# UNITED STATES PATENT AND TRADEMARK OFFICE

10/568,808

<b>Office Action Summary</b>	Application No.	Applicant(s)	
	10/568,808	HARATANI ET AL.	
	Examiner	Art Unit	
	Mohammad Ghazzawi	2809

## DETAILED ACTION

**FIG. 7**

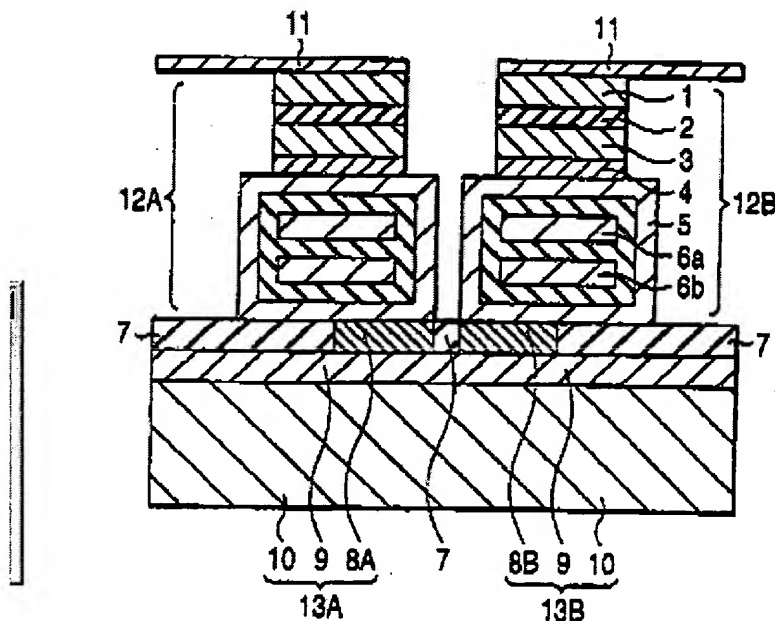
Regarding claims 1, 2, & 4, Ezaki discloses (page 3, para 0020) and shows in figure 7:

- a plurality of magnetoresistance elements each including a laminate including a magnetosensitive layer having a magnetization direction variable in accordance with an external magnetic field and adapted to allow an electric current to flow in a direction perpendicular to a laminated surface of the laminate;
- an annular magnetic layer disposed on one surface side of the laminate;
- figure 7 shows the annular magnetic layers [5] arranged side by side.

Furthermore, Ezaki discloses the claimed invention except for the magnetosensitive layer having a thickness set in a range of not less than 0.5 nm, to not more than 40 nm. It would have been obvious to one of ordinary skill in the art at the time of the invention was made to modify Ezaki, since it has been held that where the general conditions of a claim are disclosed in the prior art, discovering the optimum or working ranges involves only routine skill in the art. In re Aller, 105 USPQ 233.

Regarding claim 5, figure 7 shows a plurality of the conductors [4] extending through the plurality of annular magnetic layers [5], and the plurality of the conductors

extend in parallel to each other in a region where the plurality of the conductors extend through the plurality of annular magnetic layers.
